Retrofit Emission Control Devices (REC)

Proposal for the 01 series of amendments to the UN Regulation on uniform provisions concerning the approval of Retrofit Emission Control devices for heavy duty vehicles

**Submitted by the Chair of the informal working group on Retrofit
Emission Control devices (REC)***

"Annex 4

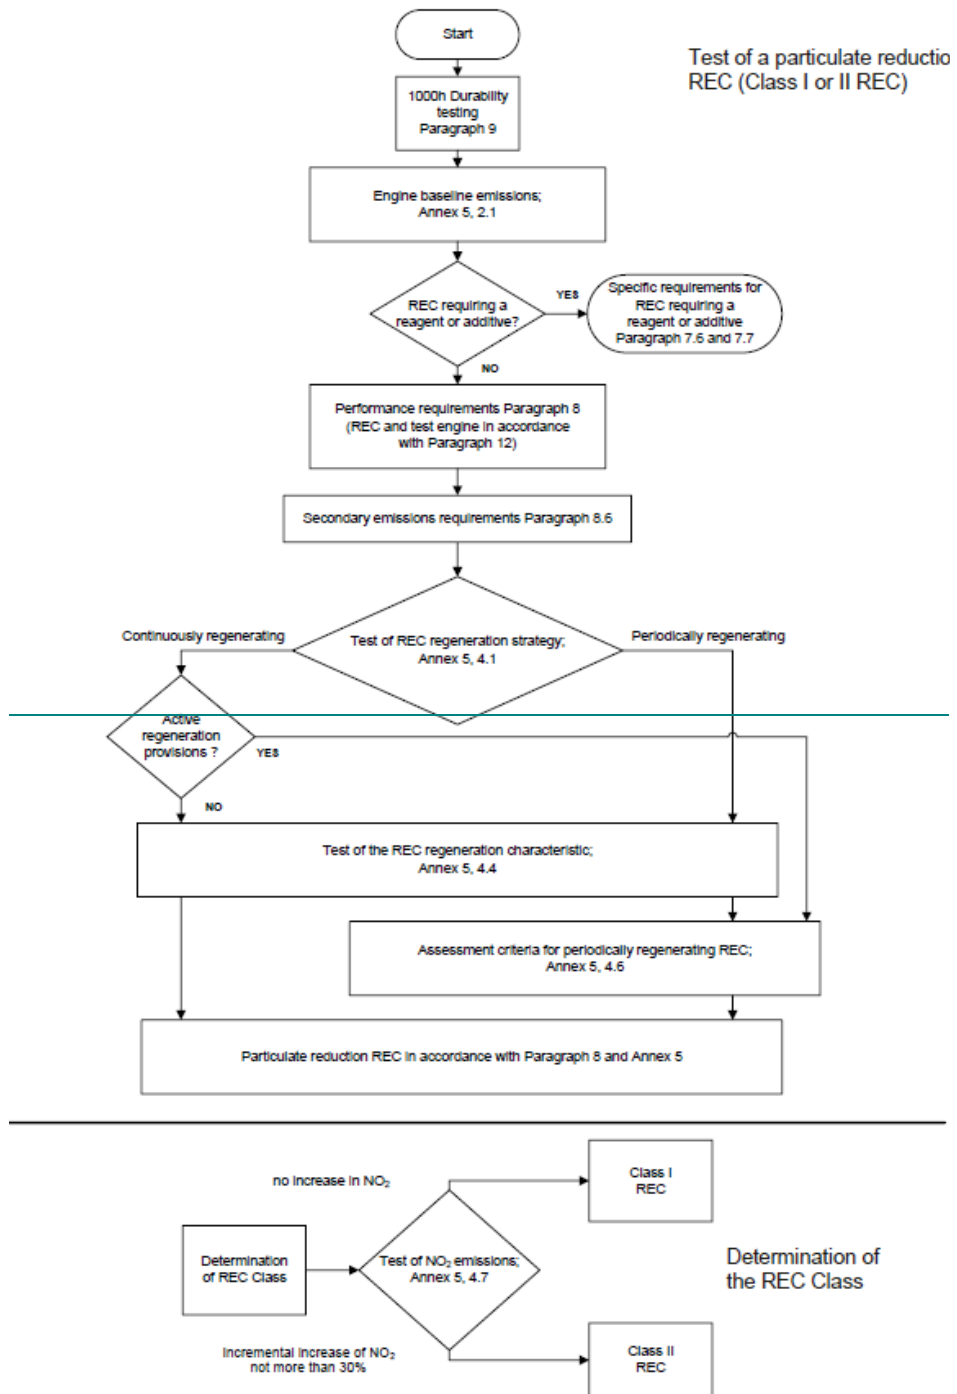
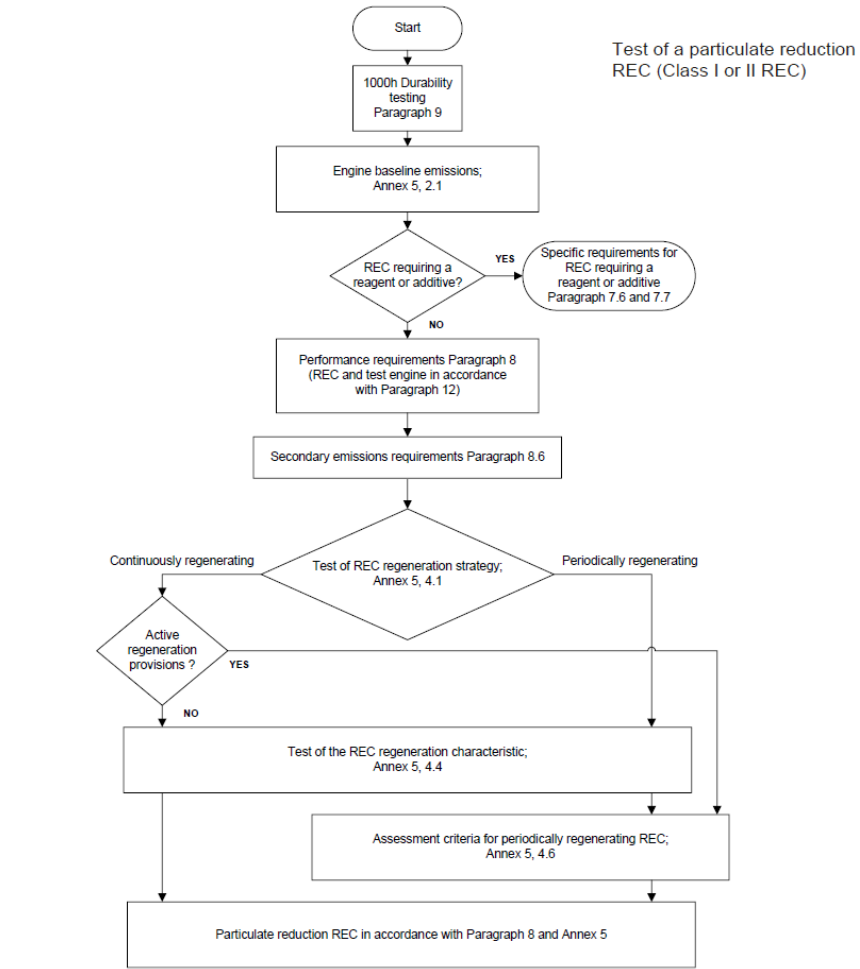
Annex 4, amend to read:

Arrangement of the REC ~~System~~-Type-Approval mark

The above example type-approval mark affixed to a REC shows that the type concerned has been approved in the Netherlands (E4), pursuant to Regulation No. [nnn] under type-approval No. 001234. The first two digits of the type-approval number indicate that the approval was granted in accordance with the requirements of Regulation No. [nnn] in ~~its original~~the form amended by this series. The approval mark shall also show the Class of REC (I, IIA, IIB, III or IV)."

"Annex 8

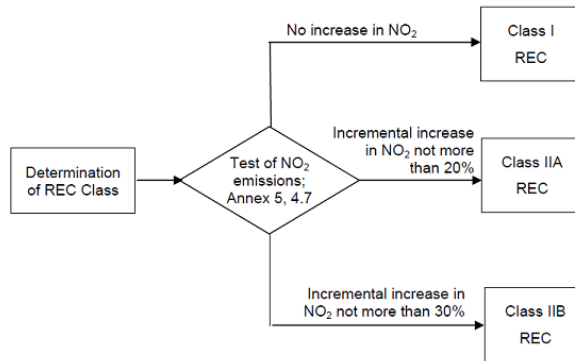
Annex 8, amend to read:

1. Test sequence for particulate reduction REC

Determination of the REC Class
